Service Bulletin – 1.25

Engine type:	EOS QUATTRO
Time of release:	July 2025
Status:	mandatory
Subject:	Decompression Stopper Replacement
Affected Serial numbers:	A102001 to A102130

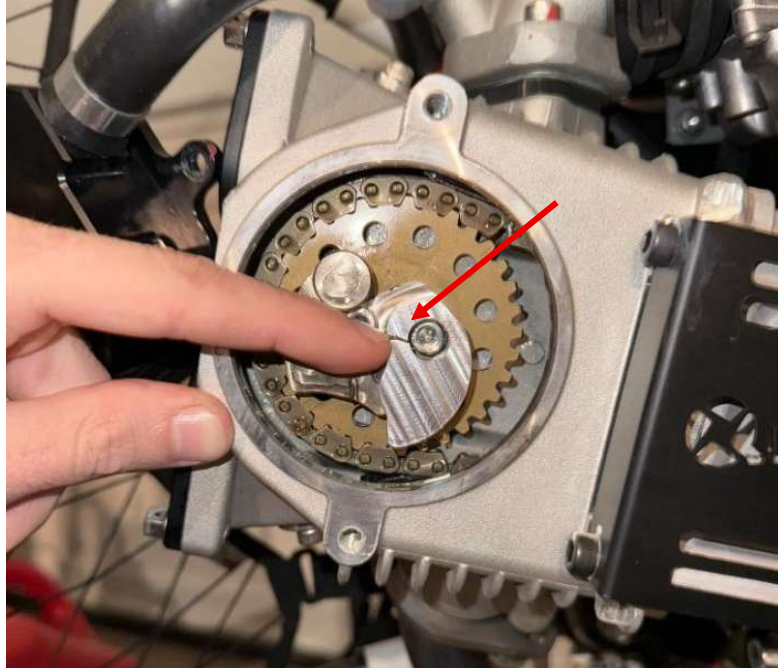
We have received isolated reports of decompression stopper failures. After careful analysis, we identified that the issue can occur due to improper starting procedures (e.g. starting with an open throttle) or using an overpowered battery. Symptoms: The engine starts poorly or does not deliver its usual performance. We already changed this part on some of the engines – if your engine already has got a new decompression stopper there is nothing to do.

The new stopper is manufactured from high-grade steel, replacing the previous 7075 alloy version, for greater durability.

Please inspect the decompression stopper for any visible damage (see reference picture below).

If you notice any cracks or signs of failure, do not start the engine until the stopper has been replaced

We are offering a replacement stopper free of charge.

- Carefully remove the two M5 screws from the decompression stopper.
- **Important:** Ensure the sprocket does not slip off the camshaft during this process.
- After installing the new stopper, tighten the M5 screws to 8 Nm, please use blue Loctite
- Video link: <https://youtu.be/JpMLbHwK3G0>
